**CITY OF KIRKLAND**  
**Planning and Community Development Department**  
**123 Fifth Avenue, Kirkland, WA 98033**  
**425.587.3225 www.kirklandwa.gov**

**To:** Design Review Board  
**From:** Tony Leavitt, Associate Planner  
**Date:** September 1, 2015  
**File No.:** DRV15-01554  
**Subject:** **PARK LANE MIXED USE PROJECT  
DESIGN RESPONSE CONFERENCE**

# Design Response Conference **Park Lane Mixed-Use** Design Proposal Packet

SITE PLAN

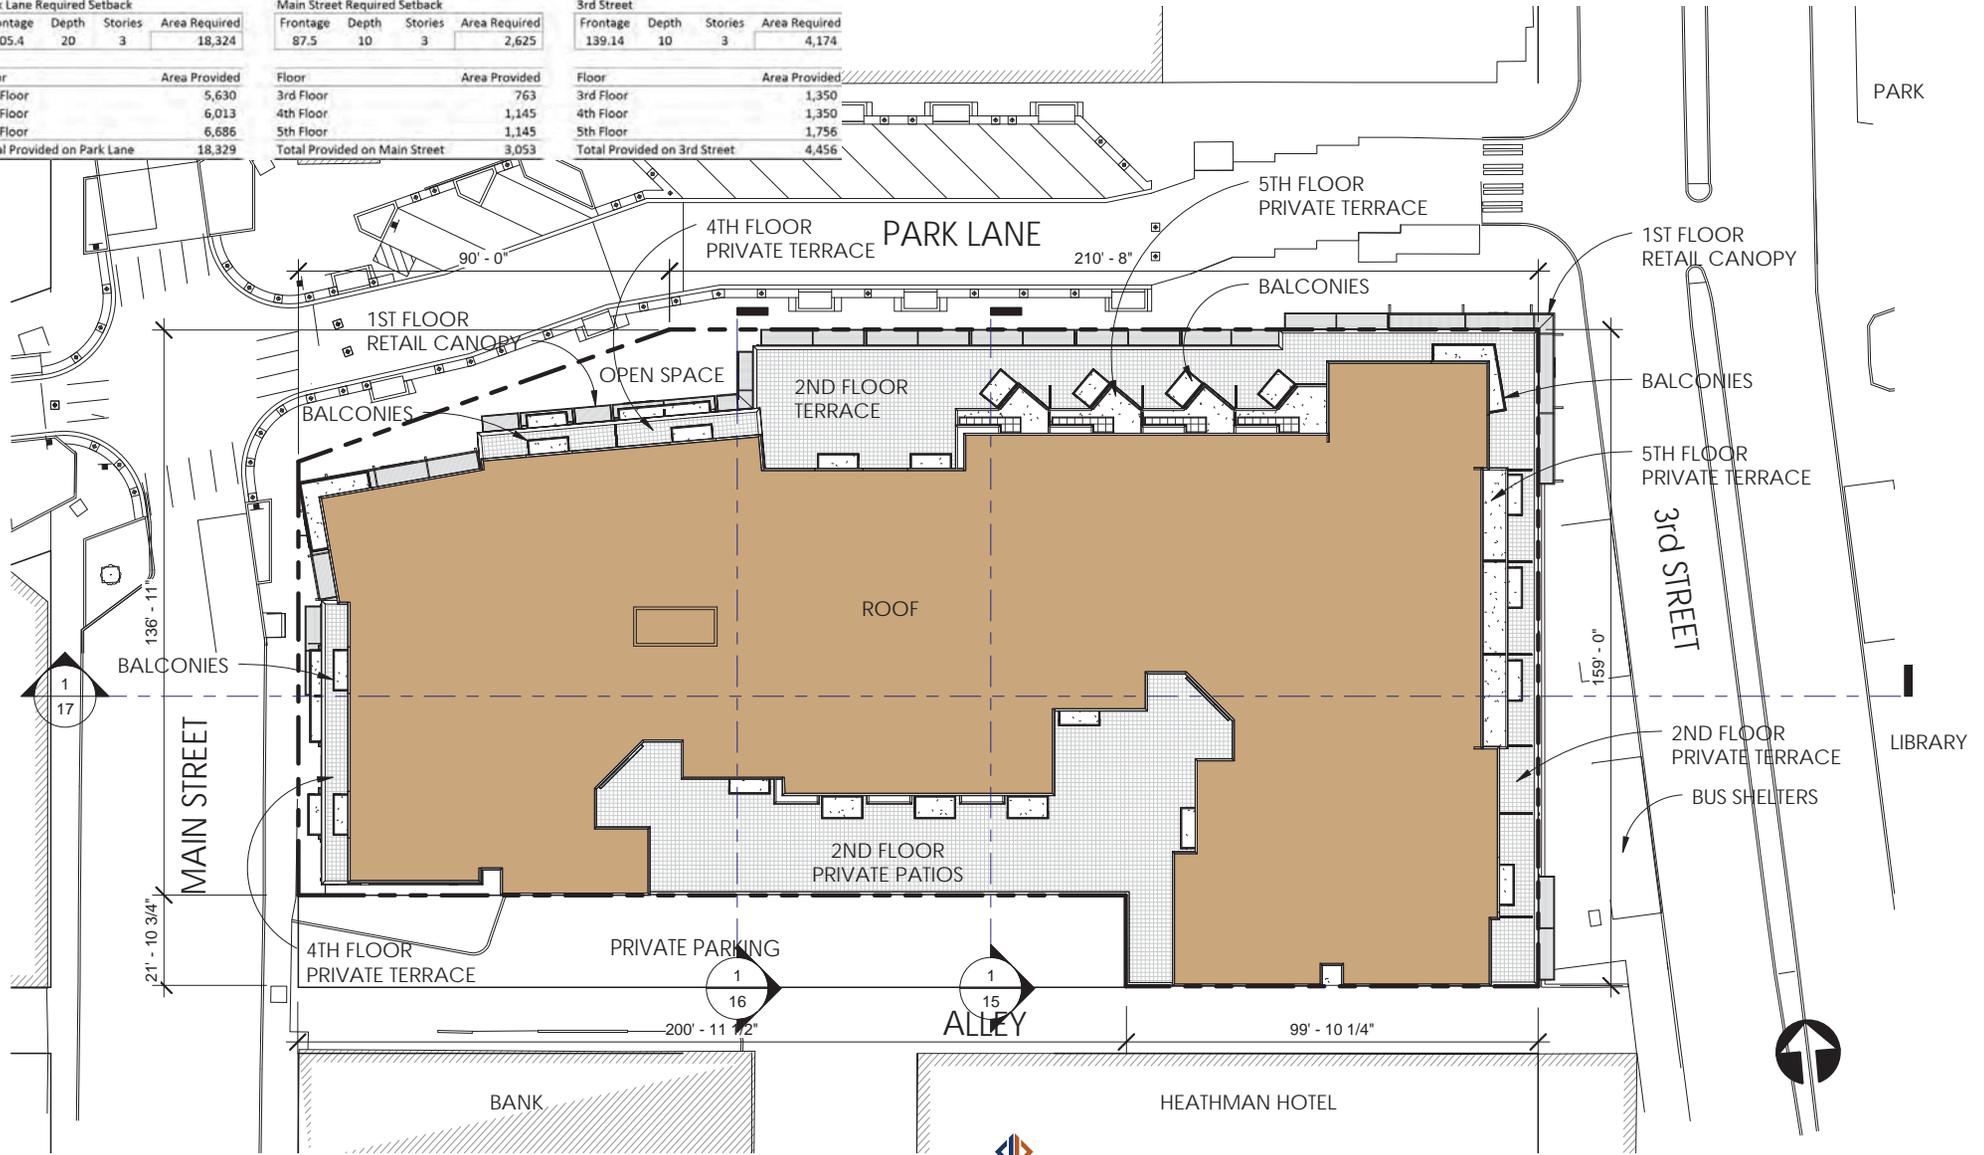
- B. Upper Story Setbacks: Along Third and Main Street, within 40 feet of these right-of-ways, all stories above the second story shall maintain an average setback of 10 from the property line. Along Park Lane, within 40 feet of the right-of-way all stories above the second story shall maintain an average setback of at least 20 feet from the property line.

*Staff Comment: The applicant has submitted initial calculations (see Attachment 2, Sheet 7) that show compliance with the upper story setback requirement. The applicant will be required to demonstrate continued compliance with the upper story setbacks during the Design Response Conference review and the future building permit application.*

Upper Level Setback Calculations (SF)

Park Lane Required Setback			
Frontage	Depth	Stories	Area Required
305.4	20	3	18,324

Main Street Required Setback			
Frontage	Depth	Stories	Area Required
87.5	10	3	2,625

3rd Street			
Frontage	Depth	Stories	Area Required
139.14	10	3	4,174

Floor	Area Provided
3rd Floor	5,630
4th Floor	6,013
5th Floor	6,686
<b>Total Provided on Park Lane</b>	<b>18,329</b>

Floor	Area Provided
3rd Floor	763
4th Floor	1,145
5th Floor	1,145
<b>Total Provided on Main Street</b>	<b>3,053</b>

Floor	Area Provided
3rd Floor	1,350
4th Floor	1,350
5th Floor	1,756
<b>Total Provided on 3rd Street</b>	<b>4,456</b>

NORTH & EAST ELEVATION

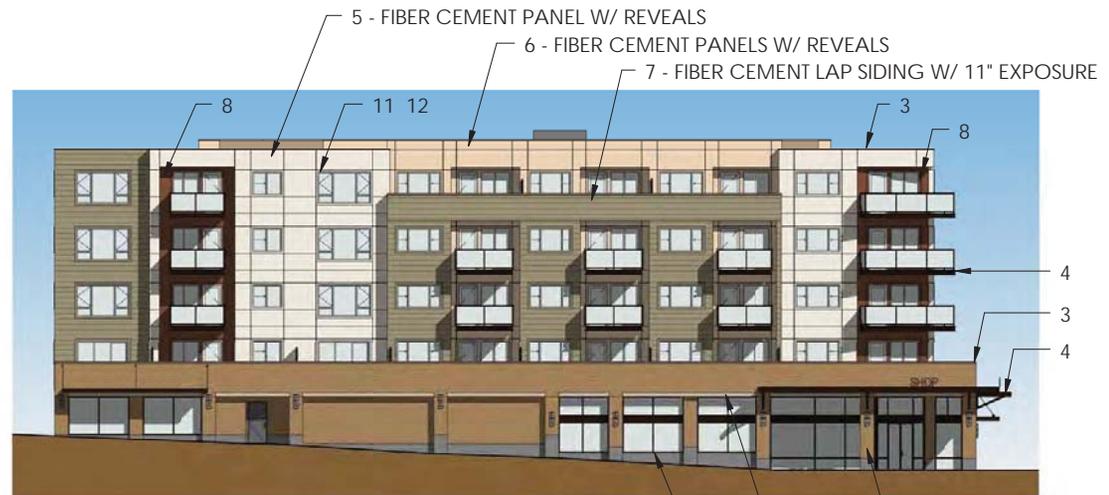
*Attachment 2, Sheets 18 and 19 contains color elevation drawings and callouts for the proposed building materials. The applicant has been directed to bring larger material samples to the DRB meeting. The DRB should provide feedback to the applicant regarding the proposed materials and colors.*
